ILLUSTRATIVE SITE DESIGNS
FOR
MULTI-FAMILY HOUSING IN PASADENA

Prepared for the Pasadena
Multi-Family Housing Task Force

Daniel Solomon and Associates
Daniel Solomon
Kathryn Clarke
Susan Haviland

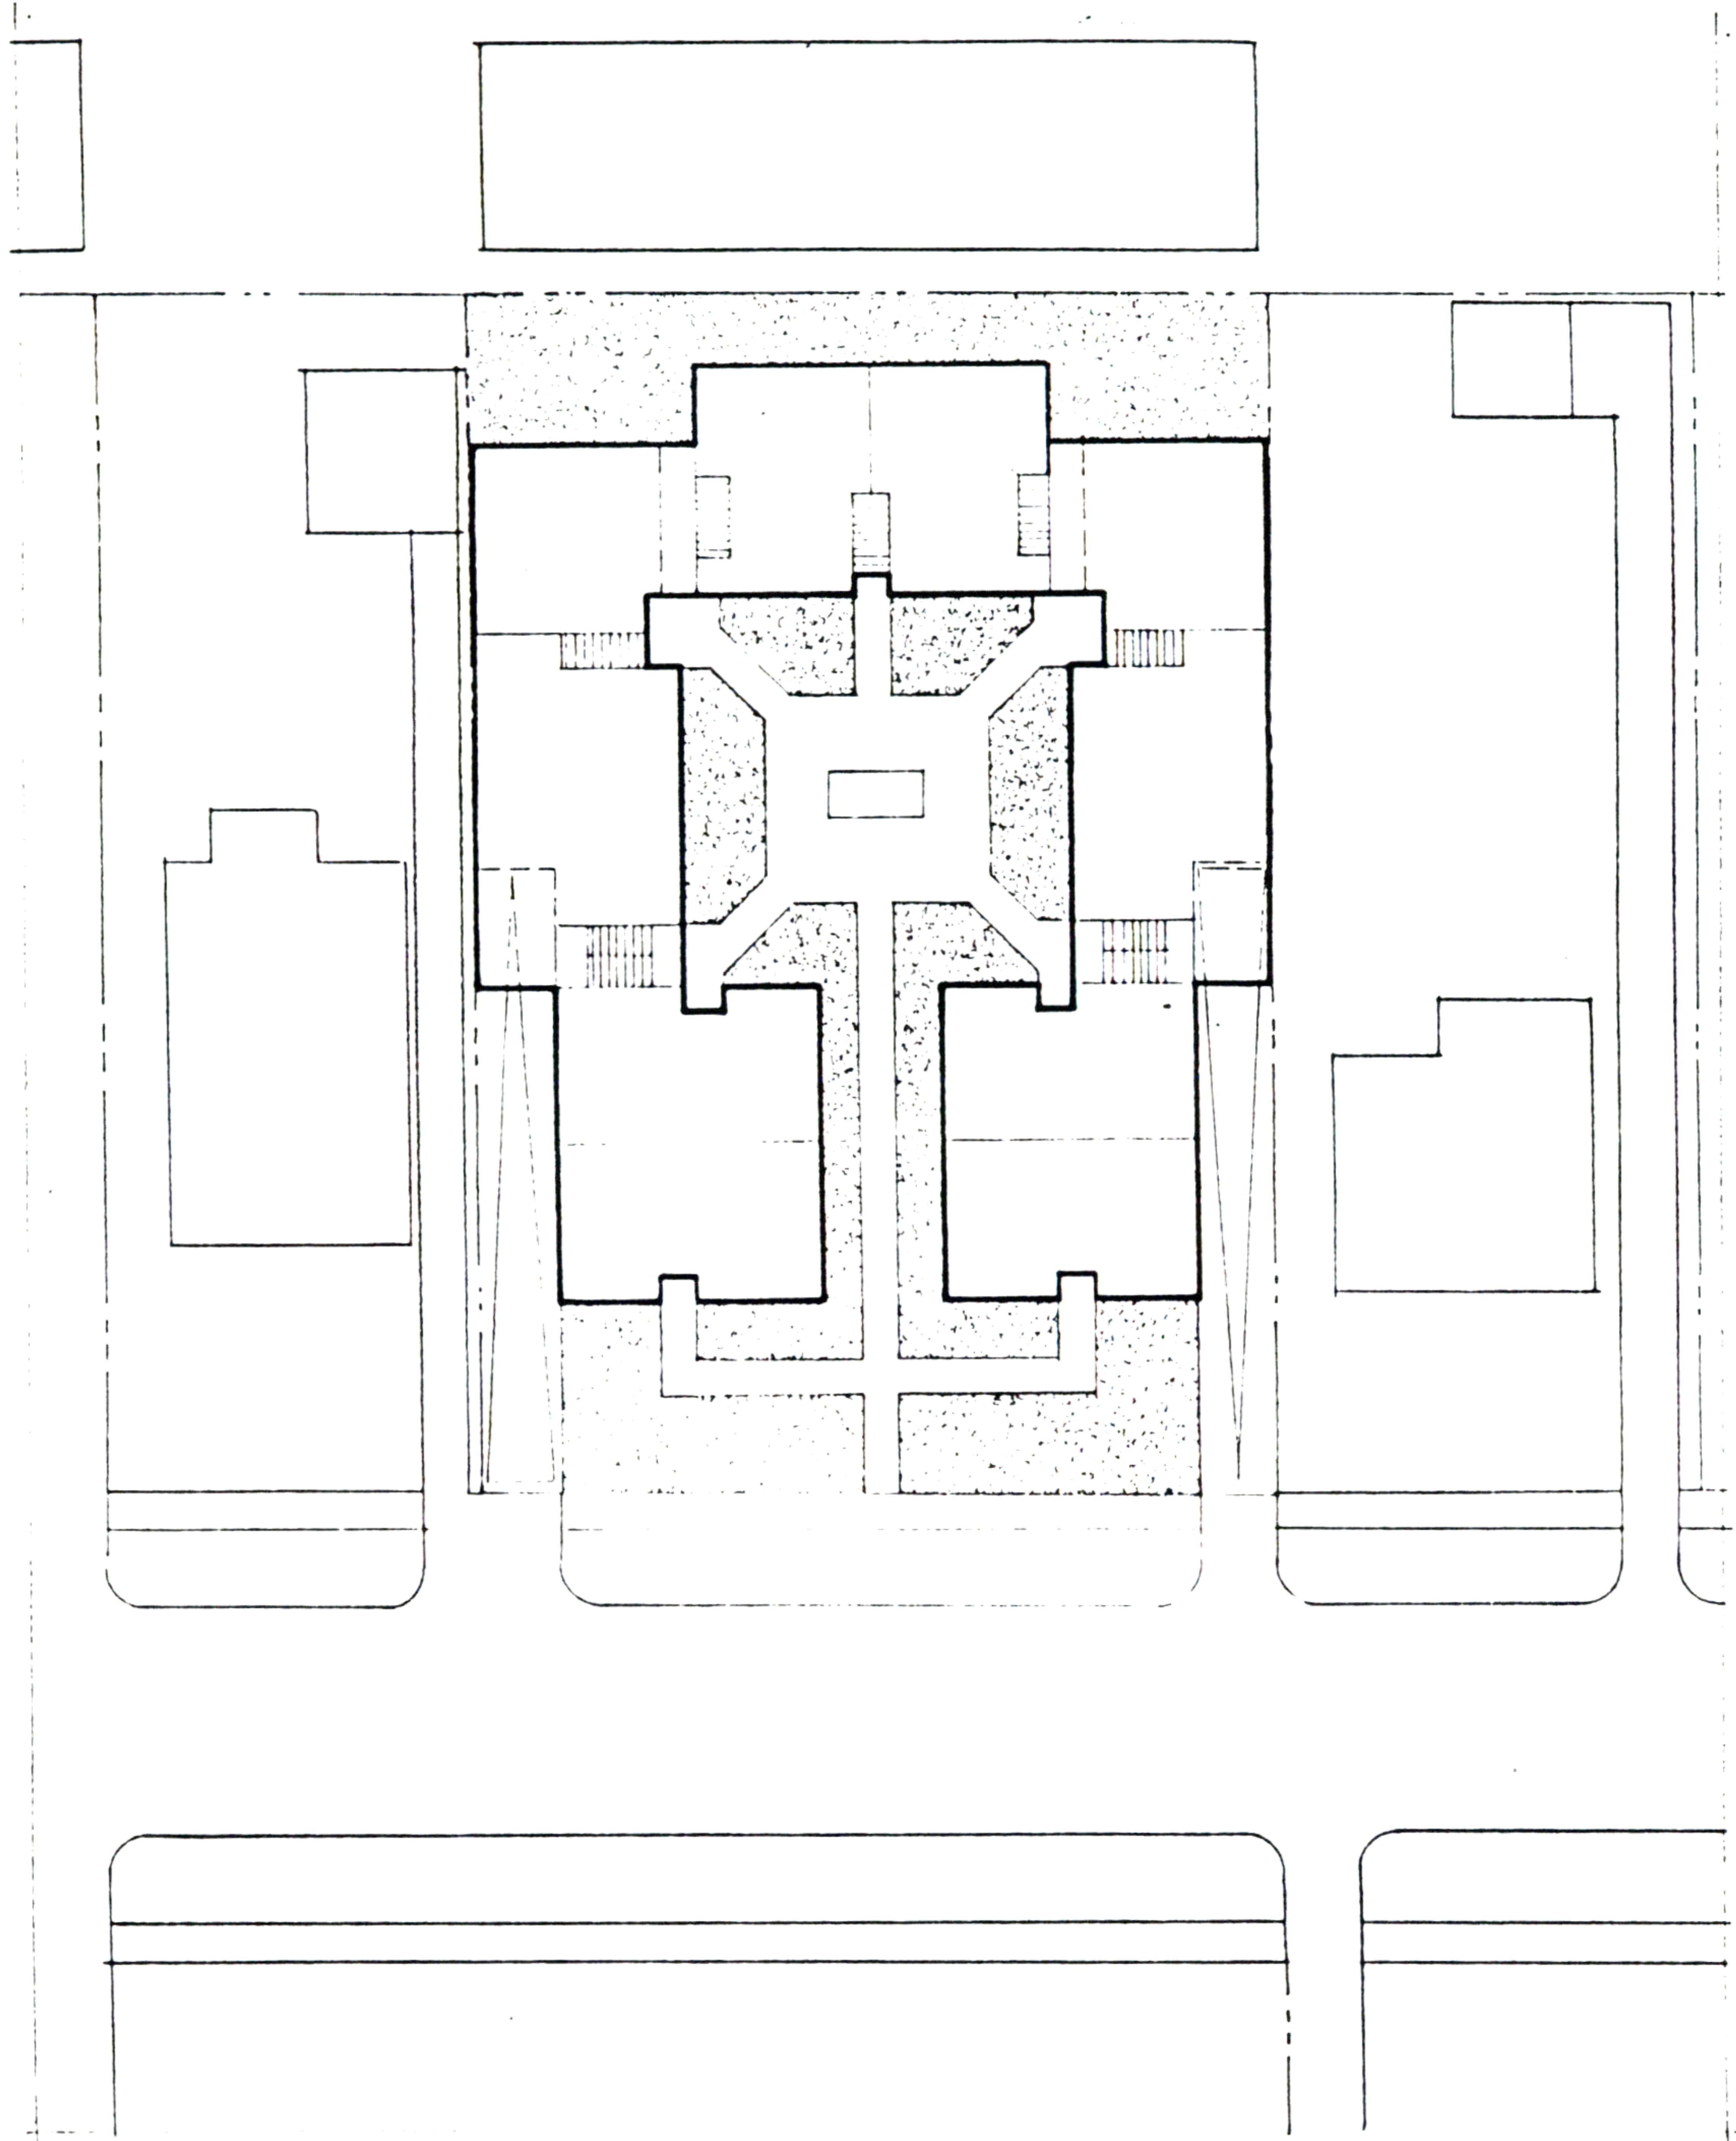
NO NUMBERS GIVEN!

DSA 32.11

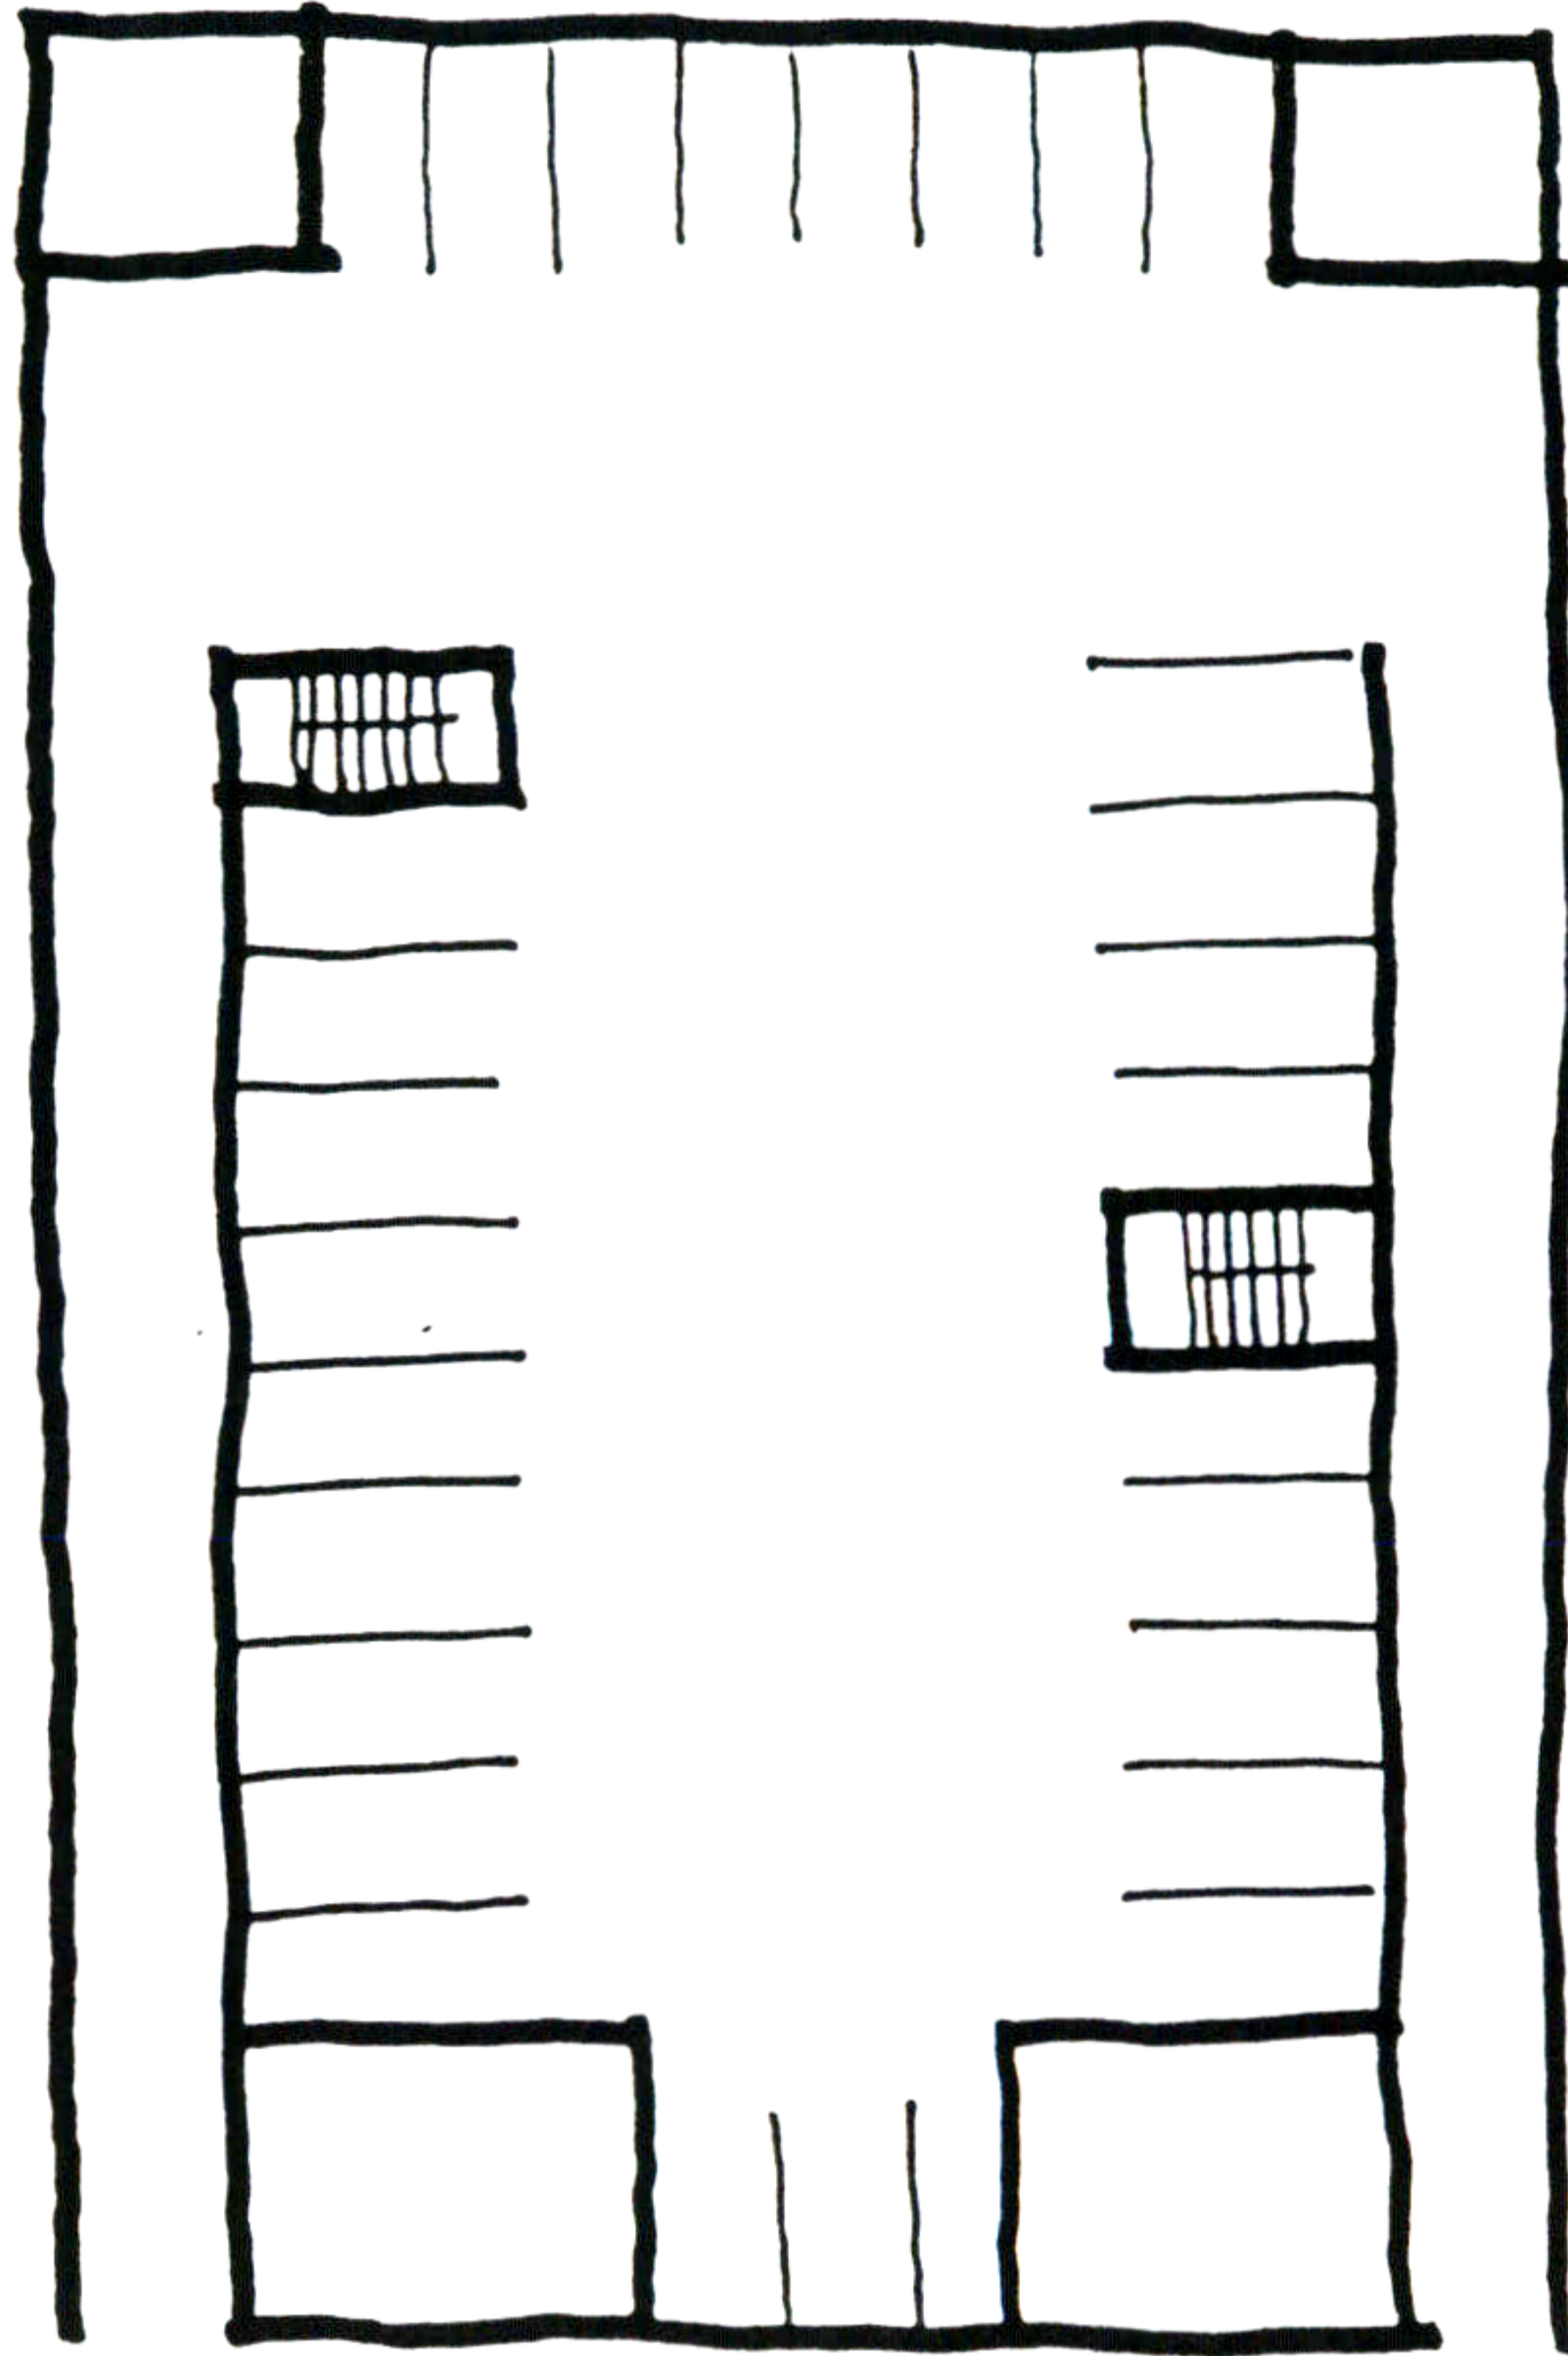
NO NUMBERS!

DSA 48.3

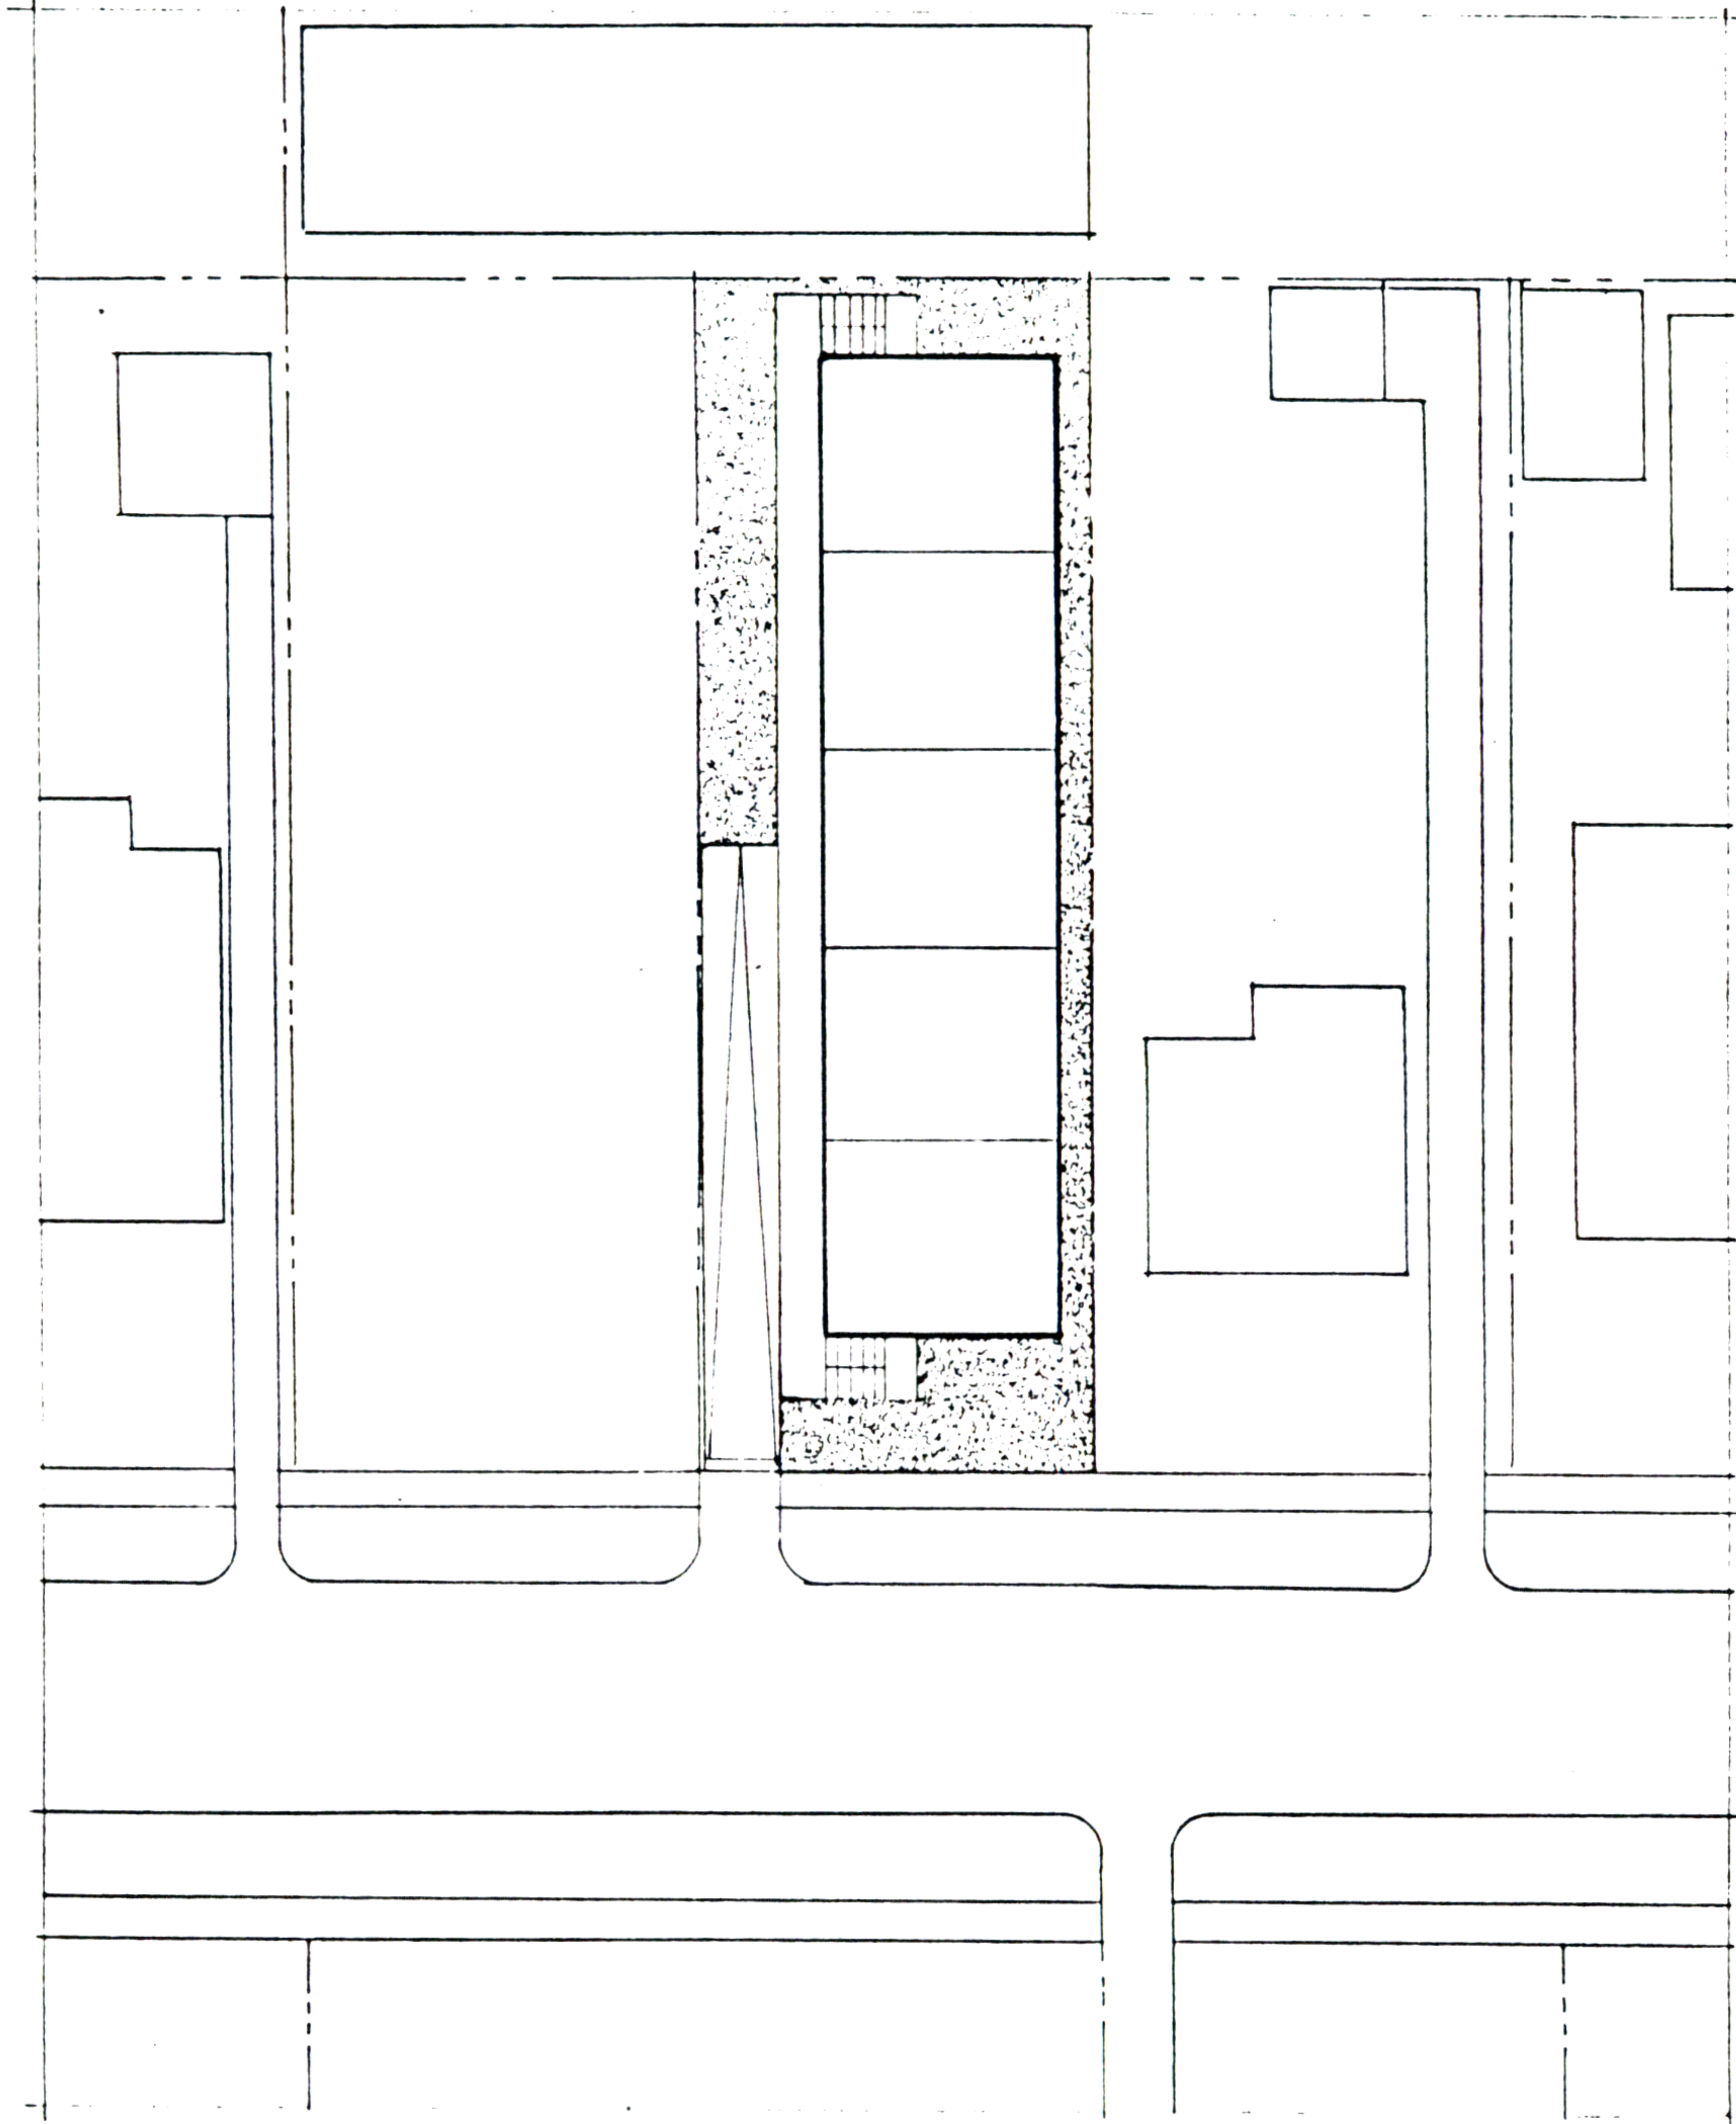
Case Study No:	DSA 48.3
Density Zone:	RM. 48
Type of Parking:	Fully Subterranean
Comments:	Unacceptable Scheme!
Lot Size:	50' x 154'
Lot Area, S.F.:	7,700
Lot Area, Acres:	.18 acre
Units:	5 IBR townhouses
DU per Acre:	27
Range:	21-55 (all IBR apts)
FAR:	1.14
<u>Parking</u>	
Provided:	
Required @,	
2 to 1:	10
1.5 to 1:	8
1 per BR:	10
1.5 and 2:	10
<u>Open Space</u>	
Main Garden:	none!
Front Yard:	
Subsidiary:	
Total:
